New England Solar Farm (SSD 9255)

UPC has prepared a response to the questions received from the Independent Planning Commission on 31 January 2020. These responses are presented at the bottom of this letter.

Attachment B – Tracker dimensions

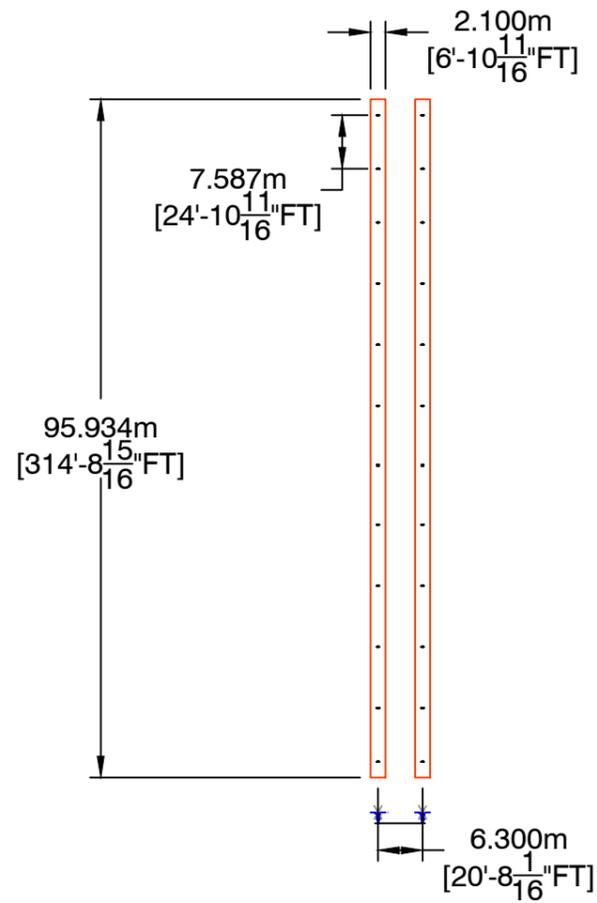
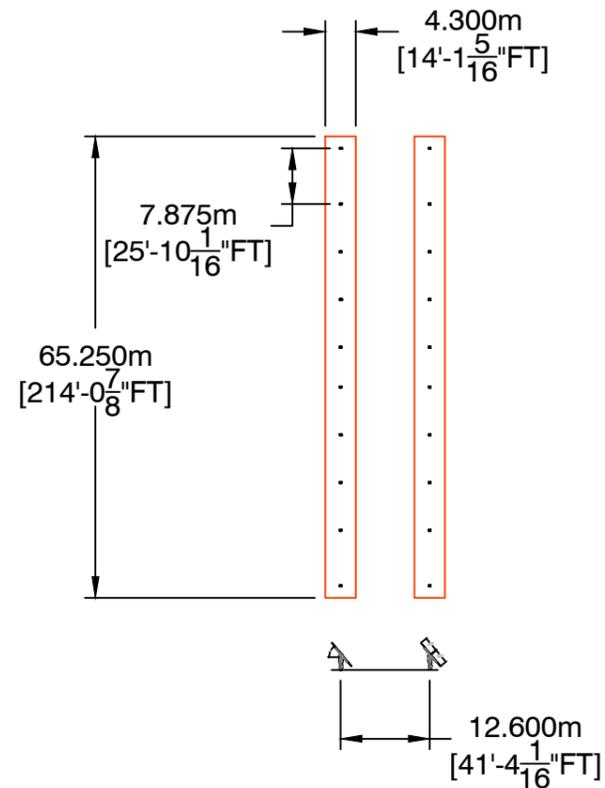
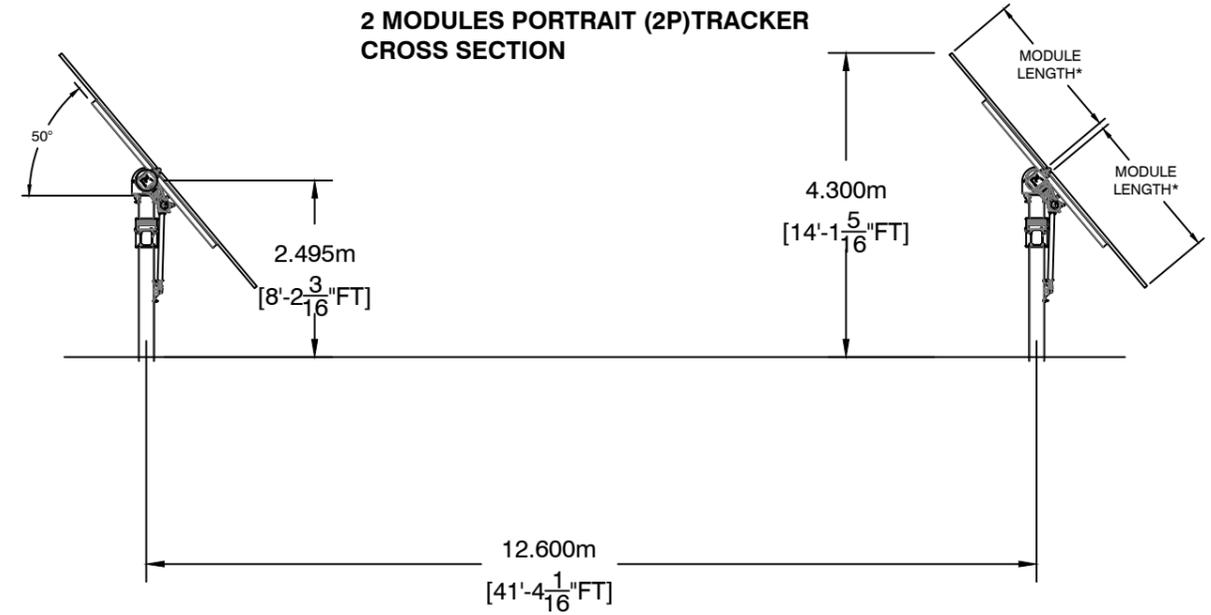
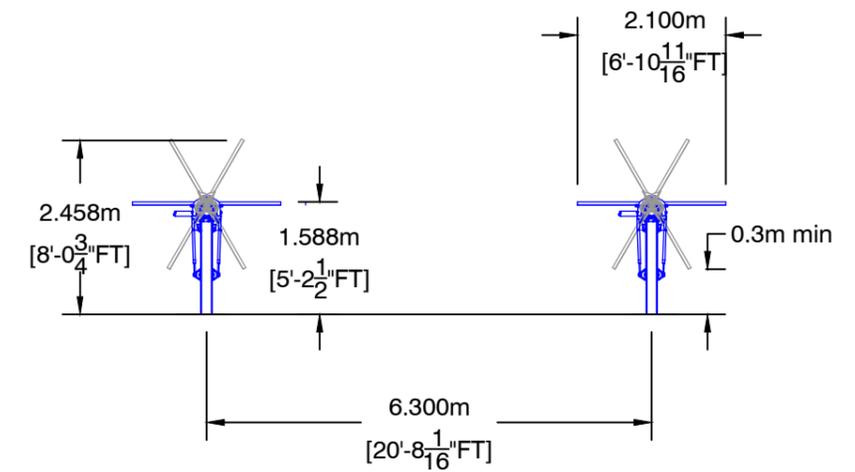
3	Can you confirm the solar array pylon spacing and depth by providing drawings of the typical layouts?	<p>An indicative technical drawing depicting the typical pylon spacing for each row of trackers, the pitch (distance between each tracker) and the maximum tracker tilt heights for a 2P and 1P tracker structure is provided for illustrative purposes as <i>Attachment B – Tracker Dimensions</i>.</p> <p>In terms of the typical embedment depth, this will be determined once geotechnical investigations have concluded for the project site and structural design of the piles and trackers has occurred.</p>

Question number	IPC question (31 January 2020)	UPC response
		<p>However, typically this depth ranges between 1.5 to 2.5 meters. The embedment depth of piles supporting a 2P tracker configuration will typically be at the higher end of this depth range, and conversely for a 1P tracker configuration, the typical embedment depth will be at the lower end of this range. It is also possible that if any areas with more reactive soils are encountered, the embedment depth will exceed this range.</p>
4	<p>Can you indicate what proportion of the workforce will be skilled and unskilled labour?</p>	<p>The exact proportion of the workforce that will be skilled and unskilled will not be known until the construction contractor commences its hiring program. Notwithstanding, UPC's preferred construction contractor has provided an indication of expected proportions based on its experience constructing large-scale solar farms in rural Australia. The following proportions of skilled and unskilled roles is expected during construction for the project:</p> <ul style="list-style-type: none"> • Qualified (University or TAFE qualified (engineers, electricians, etc)): 35% • Specialised trained (machine operator, mechanical mounter, etc): 25% • Unskilled: 40% <p>Training for many of the specialised trained roles can be undertaken locally to upskill potential employees to fill these roles.</p>
